## SEWAGE DISPOSAL SYSTEM

### DEPARTMENT OF HEALTH AND MENTAL HYGIENE

A REPAIR

SUBDIVISION Farside LOT 39 ROAD 11910 Farside Road

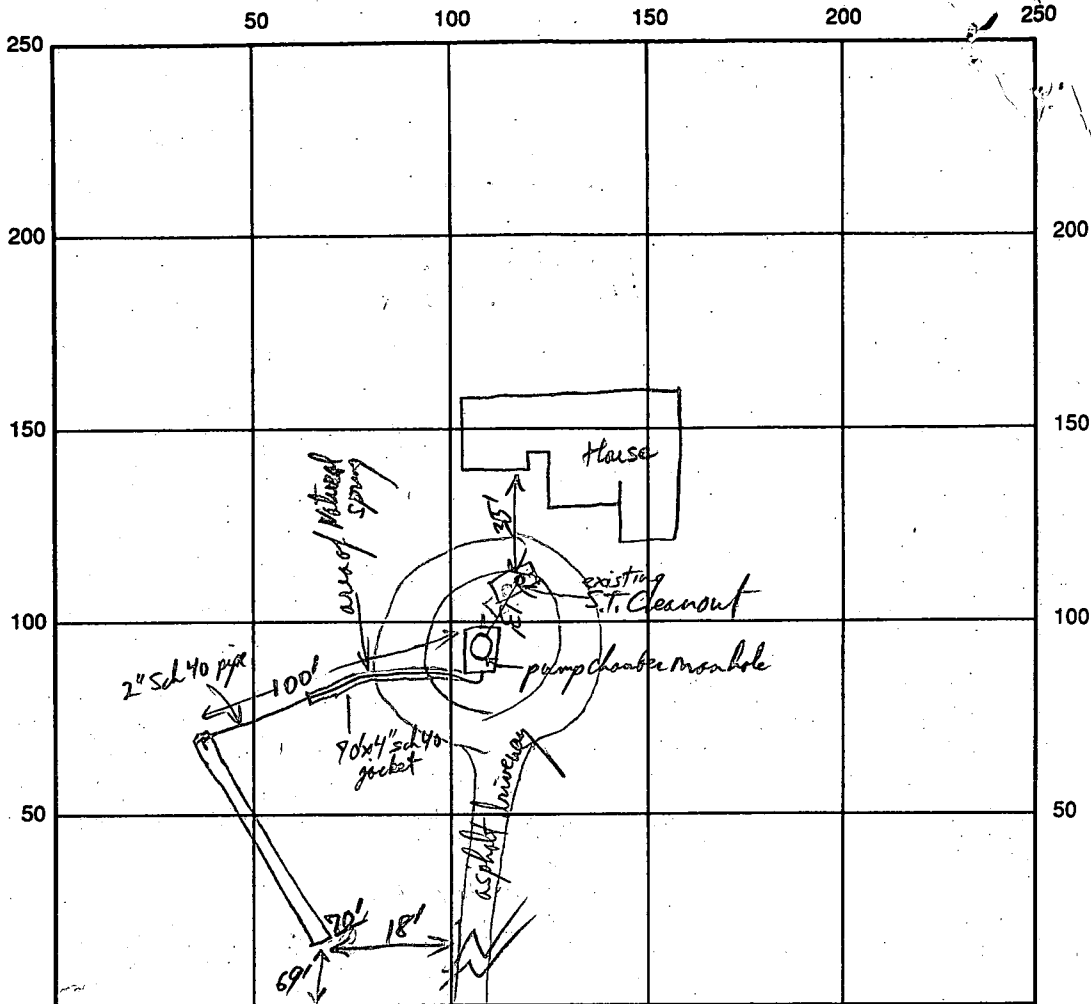
[ See next page ] C.W. Now  $\rightarrow$  70'  $\pm$  long : 2'  $\pm$  wide  
[ See original C.O. of 10/19/82 ] 9/15 (1) Trench  $\approx$  2' of stone  
(9/15/93 @ site - hit as shown) 46'  $\pm$  (Because)  $\rightarrow$  in line for pipe to C.W.  
(distribution box - need to pump now) - to get approval of pumps by  
C. W. for C. W. DATE 8/25/93 Mr. C. Wick

PLANS APPROVED BY C. W. for C. W. DATE 8/25/93  
COVER NO WORK UNTIL INSPECTED AND APPROVED  
Sick proposed using 600 gal single unit Pump Chamber with Dual Pumps - OK 9/16/93
